Our ref
PLAN-030641

Date
18/12/2019

Proposal: Listed building consent for conversion of & alterations to existing barns to create 3 no. dwellings, erection of car barns & stores, a replacement pump house, demolition of barn, associated landscaping & parking.

Site: Y/106/19/L: - Stakers Farm, North End Road, Yapton, BN18 0DU.

Southern Water MapGuide Browser

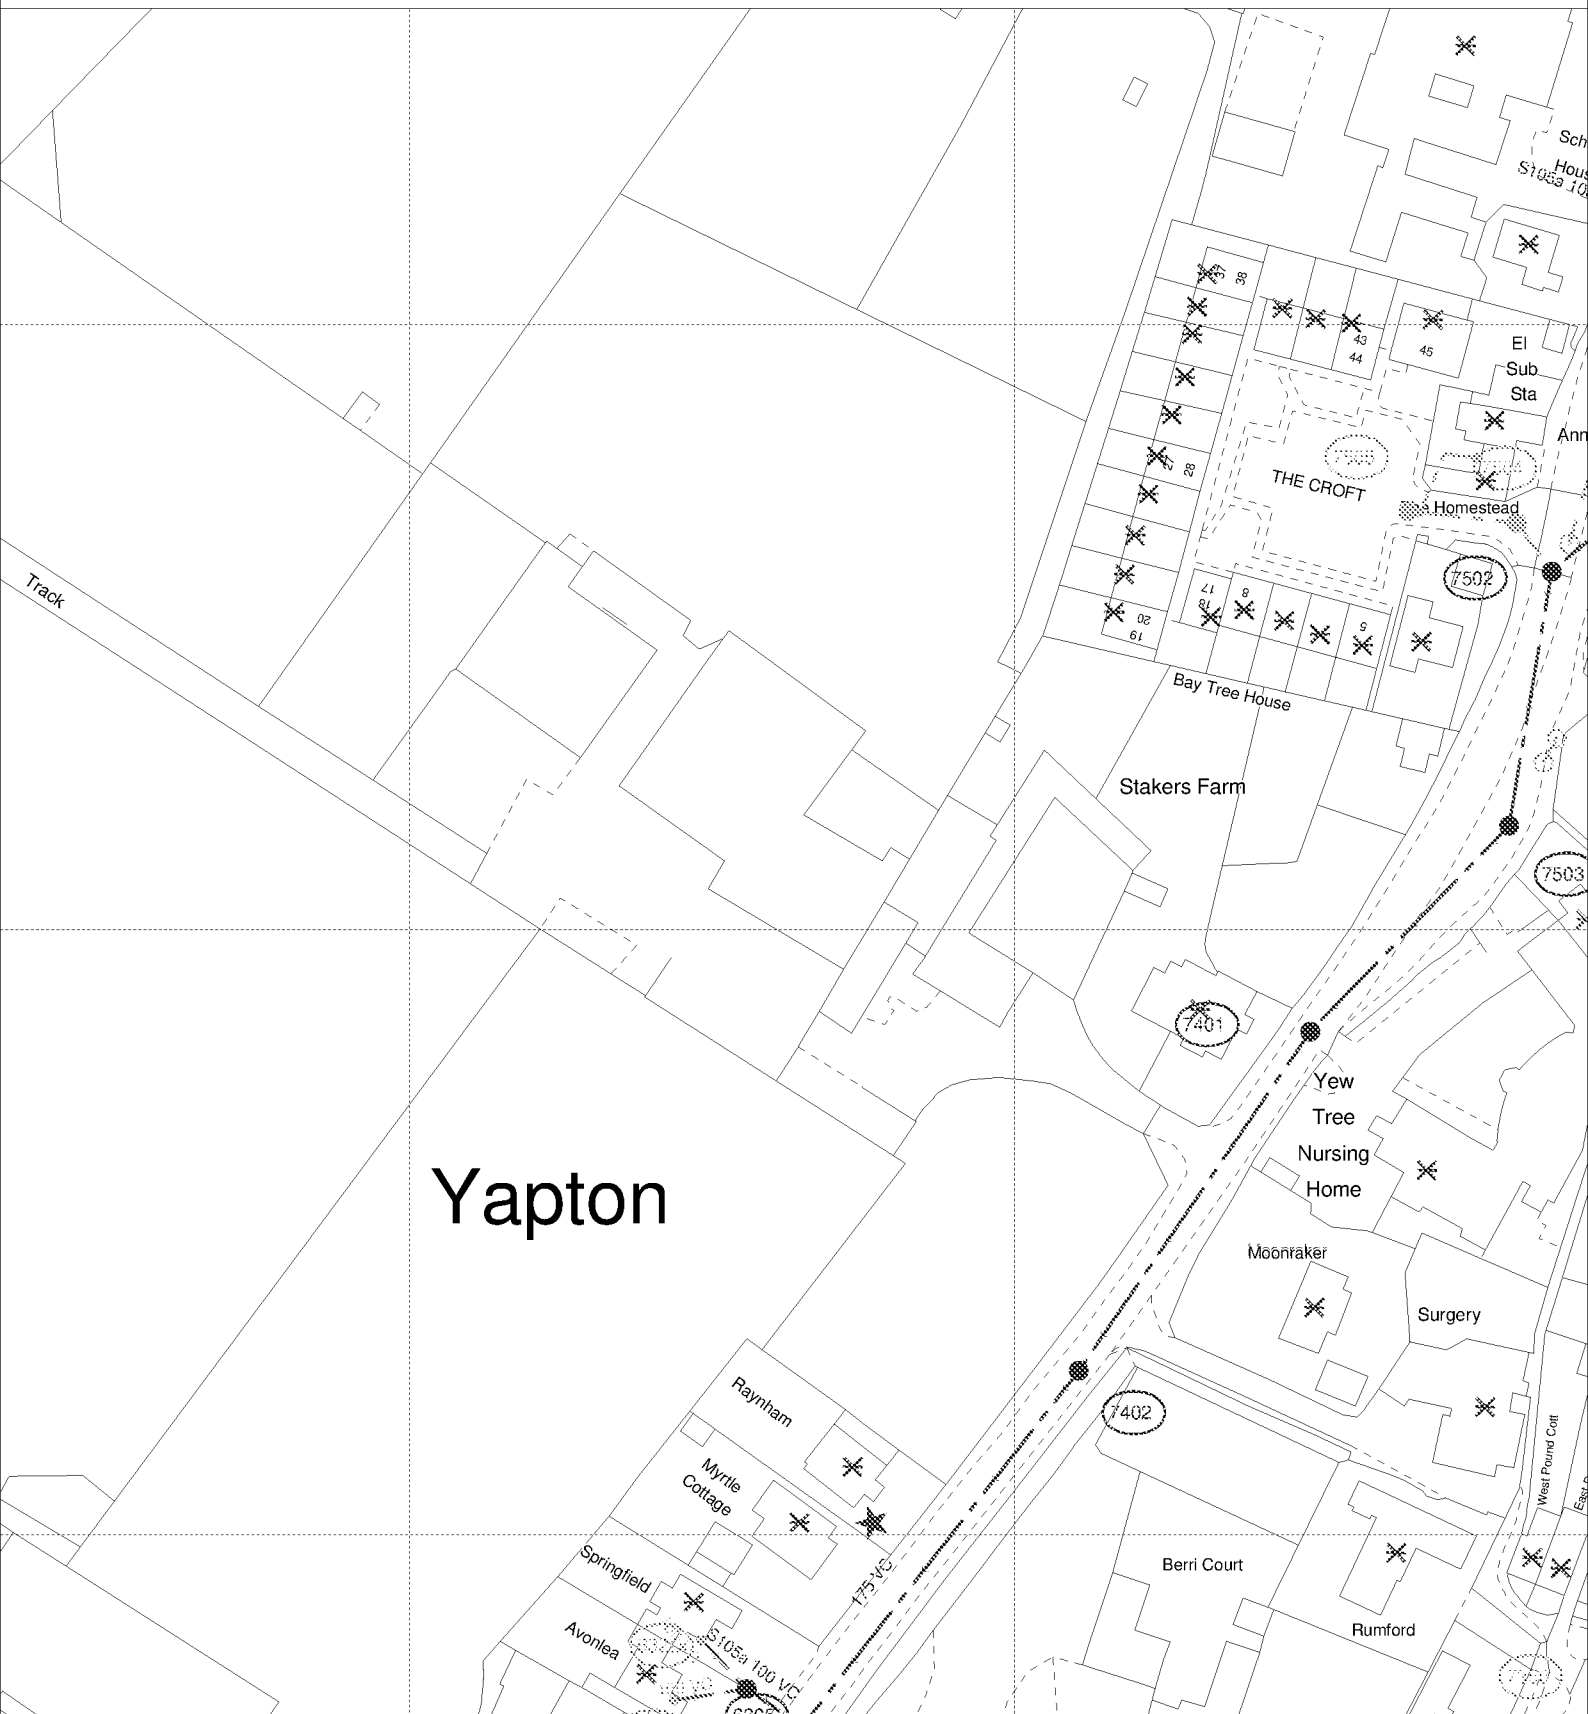
It is possible that a sewer now deemed to be public could be crossing the development site. Therefore, should any sewer be found during construction works, an investigation of the sewer will be required to ascertain its ownership before any further works commence on site.

The positions of pipes shown on this plan are believed to be correct, but Southern Water Services Ltd accept no responsibility in the event of inaccuracy. The actual positions should be determined on site.
